From: Sarah Fletcher <fletchsa1@gmail.com>
Sent: Saturday, February 11, 2023 12:52 PM
To: Kate Akyuz
Cc: Jessi Bon; Andrew Leon; Alison Van Gorp; Council; Planning Commission; Design Commission
Subject: Re: Question on the Baskin Robbins Project
Attachments: Baskin Robbins Green Roof Sedum trays 24 inches.pdf

Thank you for commenting on the proposal to construct a 10-unit apartment building at 2900 78th Ave SE, as processed under permit number DSR22-014. You have been added as a party of record for this permit.

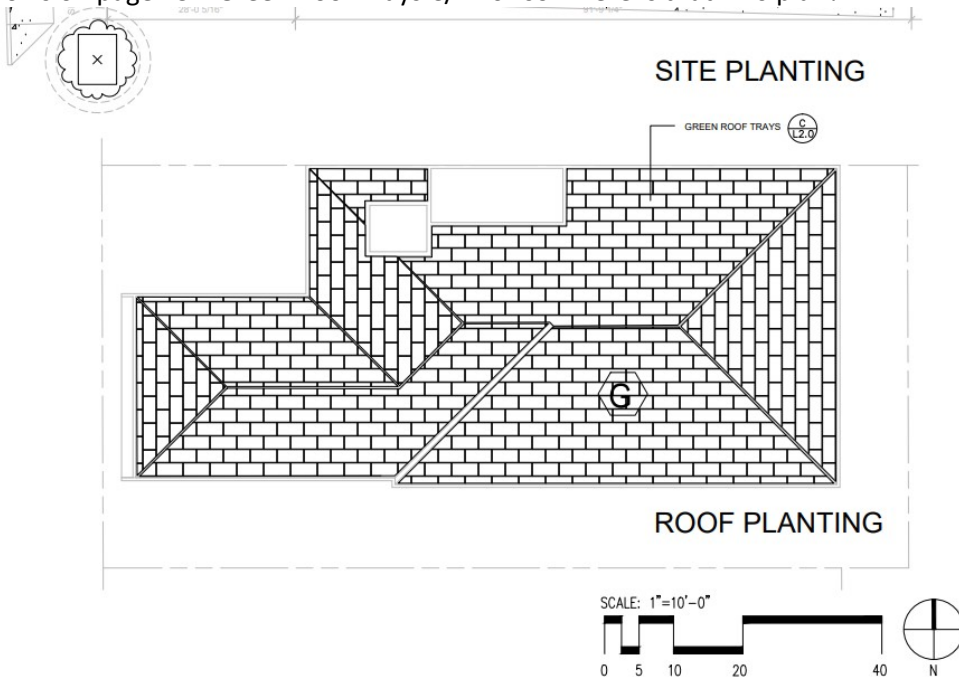
I am sorry, but did you not look at their plans? See attached (page 7). They plan on putting 24 inches worth of sorghum trays which you could buy at Home Depot and just shove them on the roof. They do not mention how they plan on securing the trays and there does not appear to be a plan L2.0.

Does it say that they are actually going to install the sorghum trays or just put them on a section of the roof? And did they mention installing leak prevention?

And are they just going to install the trays and then leave them, or is the roof the type in which people will go onto the roof to check on the plants? It is a bit odd in that the roof looks slanted. And how many flats were they planning on installing? And doesn't it look like they plan on installing it only on one section? Are they planning on installing 500 flats or how many?

And I am sorry, but one heavy rain will just overflow onto the roof itself.

And if you look at the attachment, I am a layman so I have absolutely no idea how to read the plan. What does it tell you about how big a section are the trays going onto in the middle?
